DANE COUNTY DEPARTMENT of PUBLIC WORKS, HIGHWAY and TRANSPORTATION

RFB NO. 313083 - ADDENDUM NO. 3

CONSTRUCTION OF EAST HIGHWAY GARAGE – SALT STORAGE FACILITY (BID PACKAGE A) AND MEDICAL EXAMINER OFFICE BUILDING (BID PACKAGE B)

**DEPARTMENT OF PUBLIC WORKS,
HIGHWAY & TRANSPORTATION
3562 COUNTY HIGHWAY AB
MCFARLAND, WISCONSIN**

Sheet M-003 – Site Piping Details

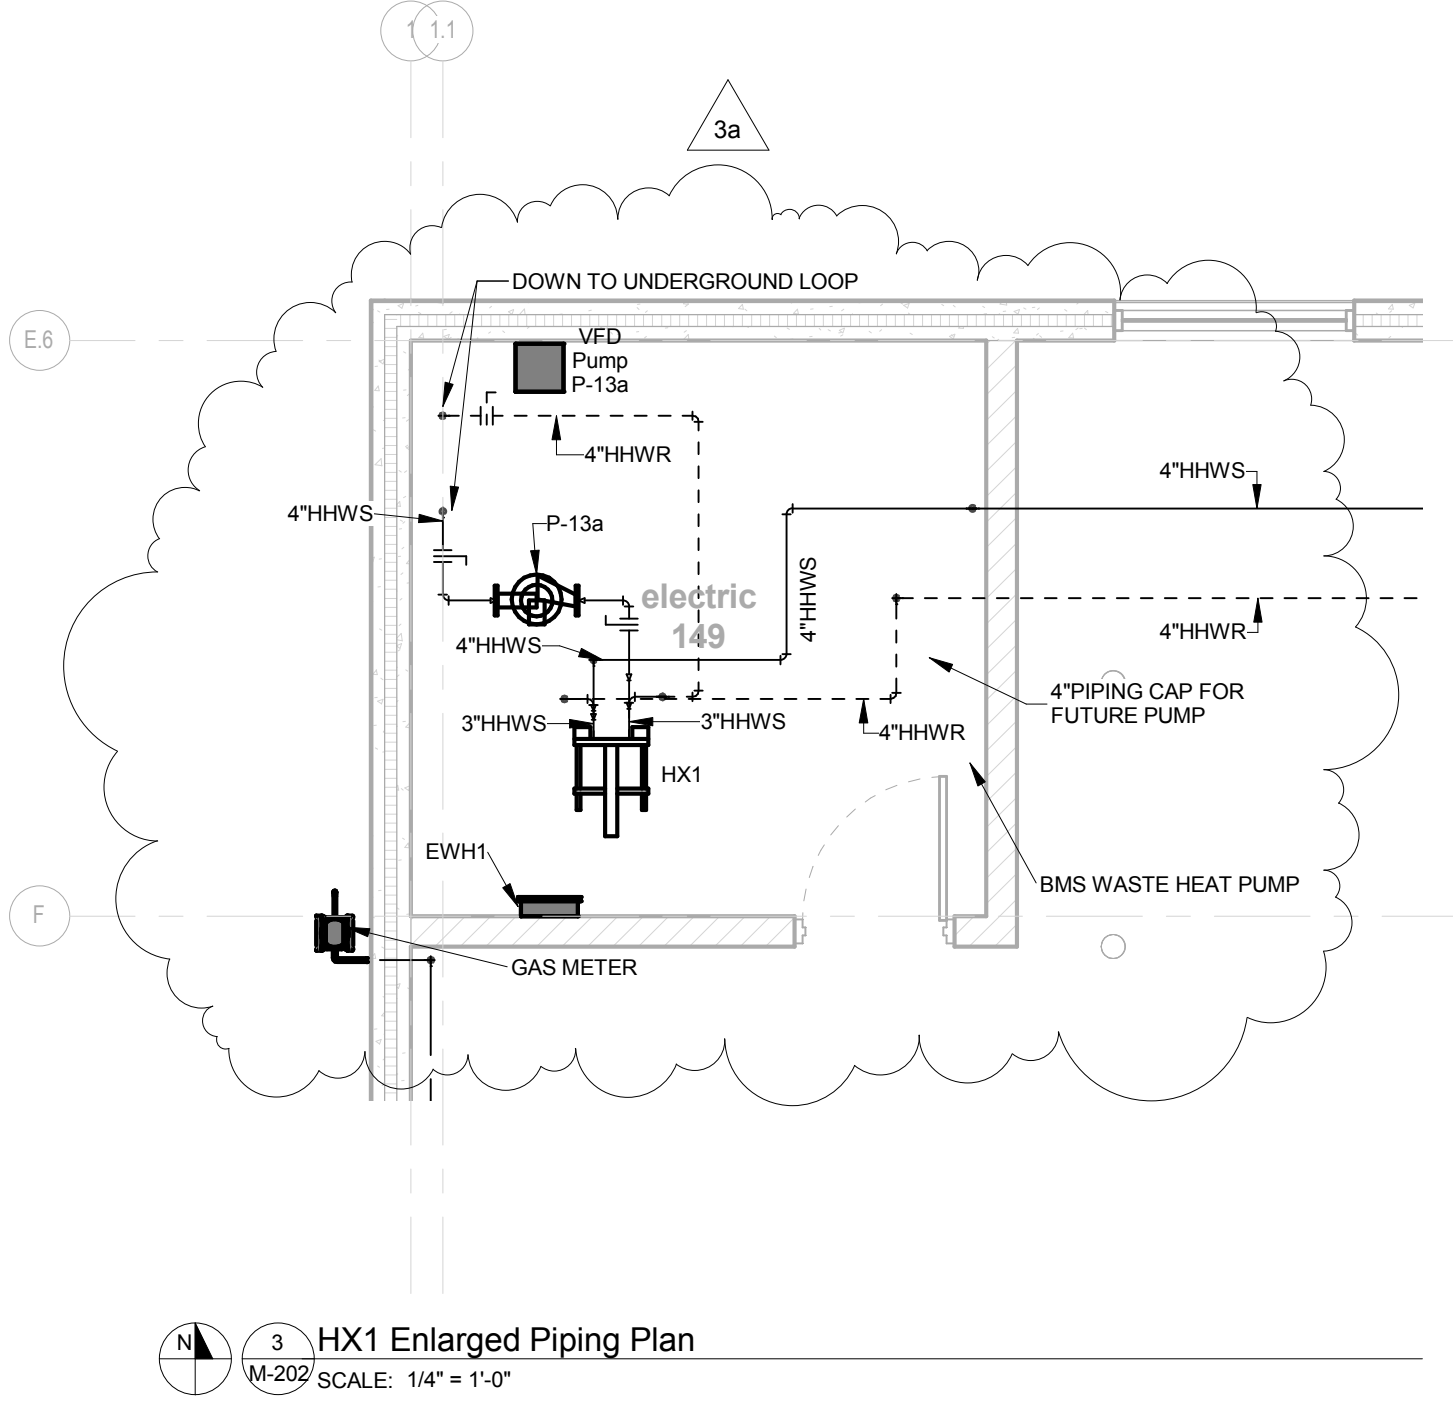
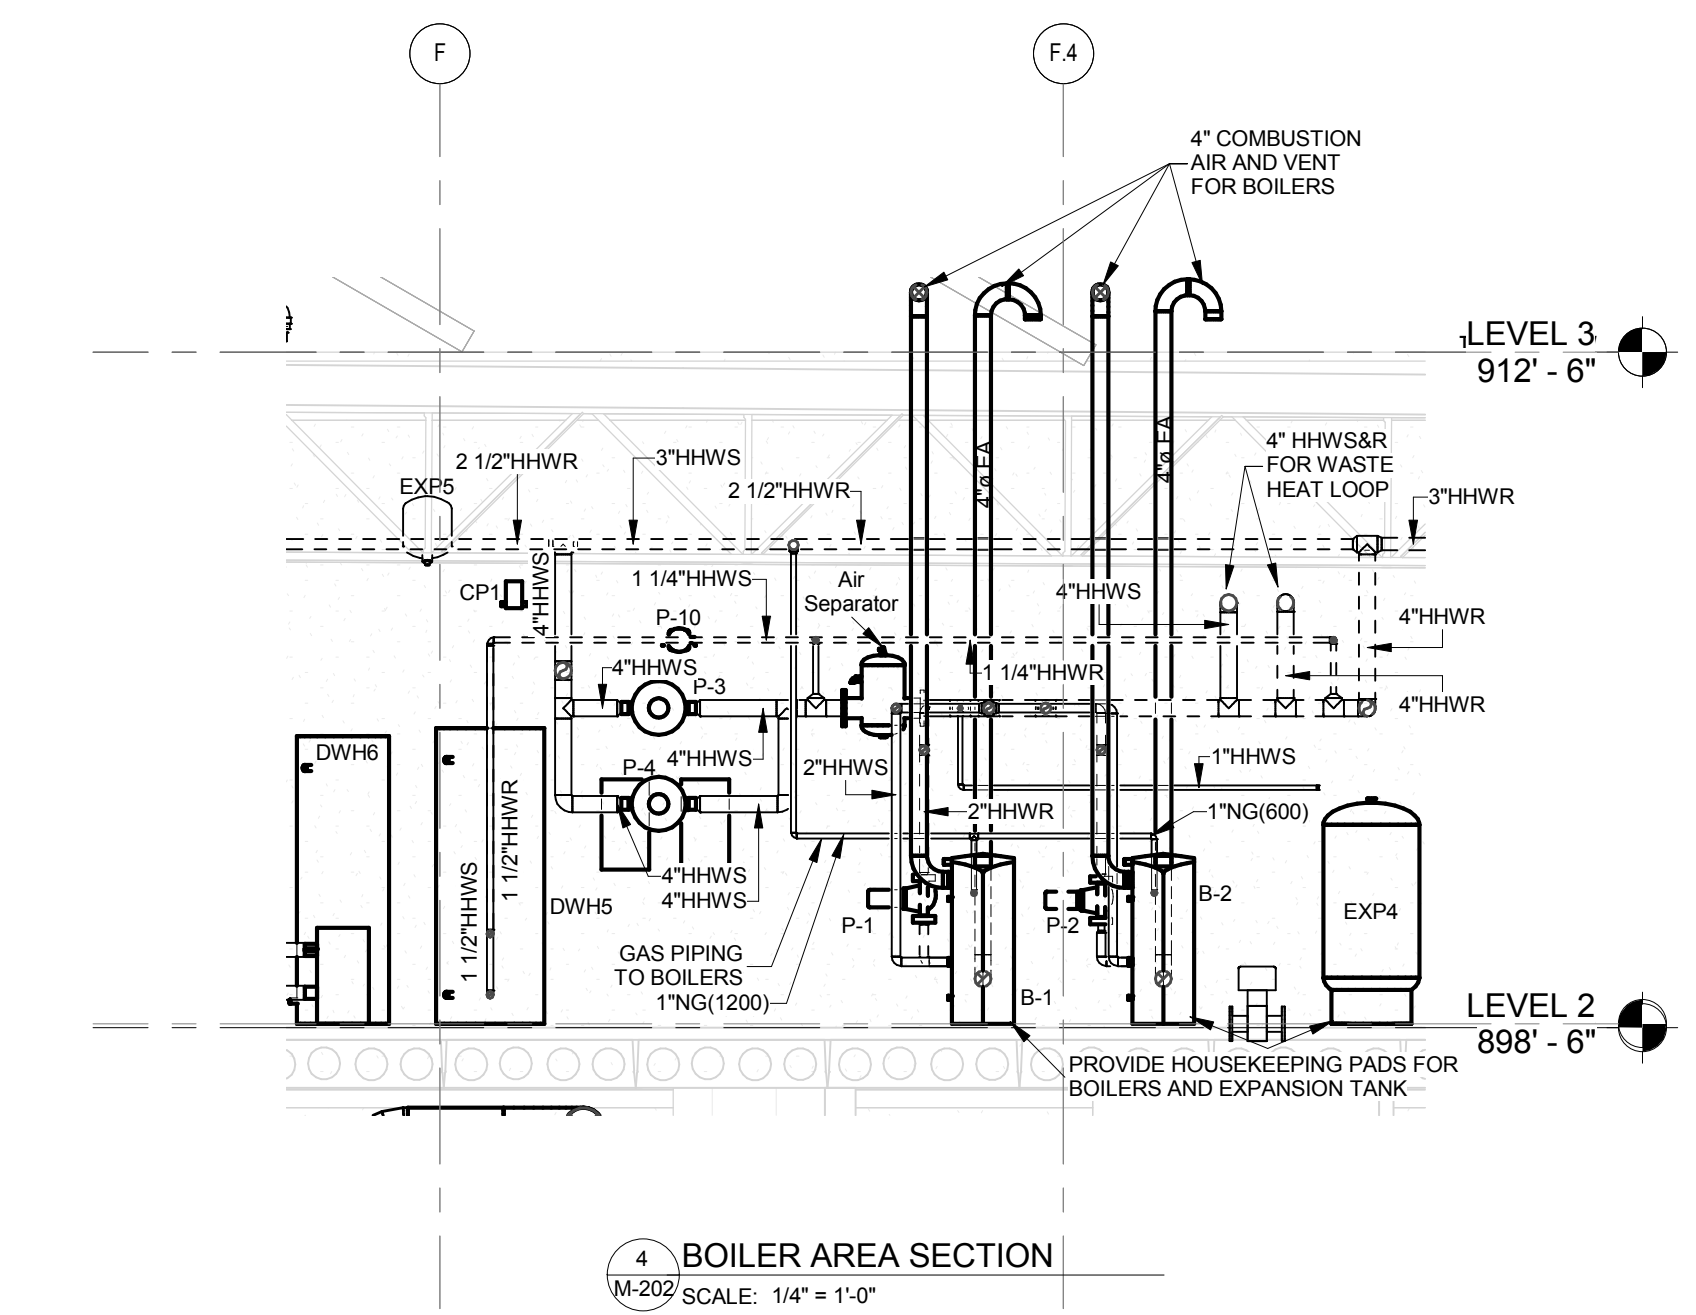
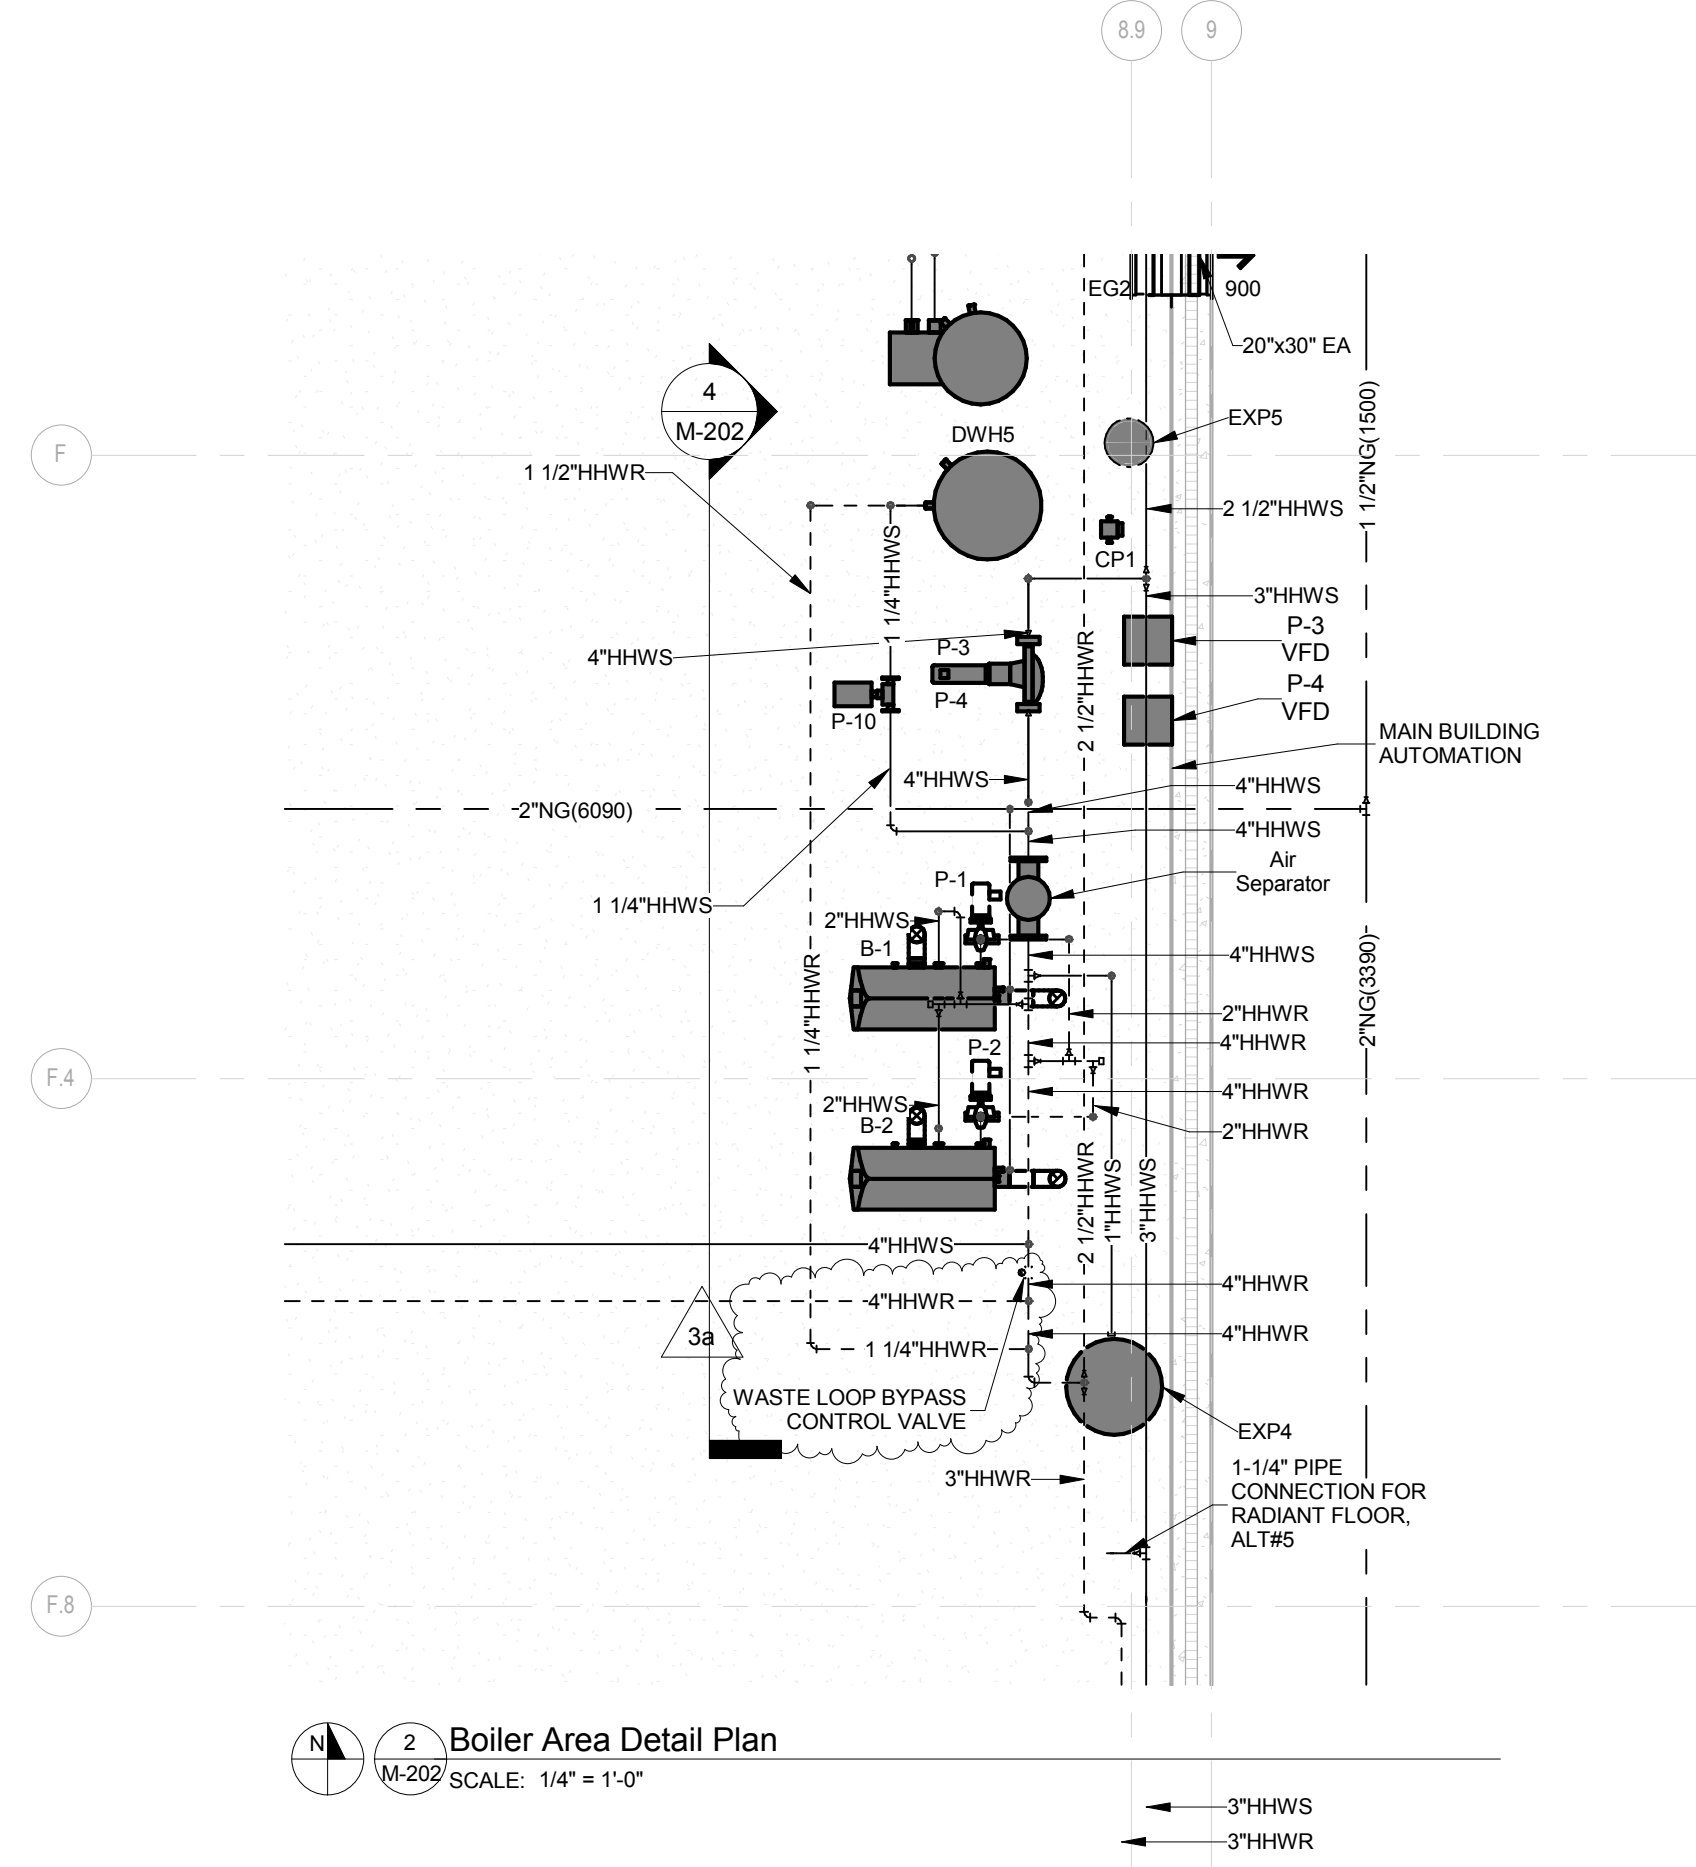
1. Site piping details relocated to Sheet M-003.
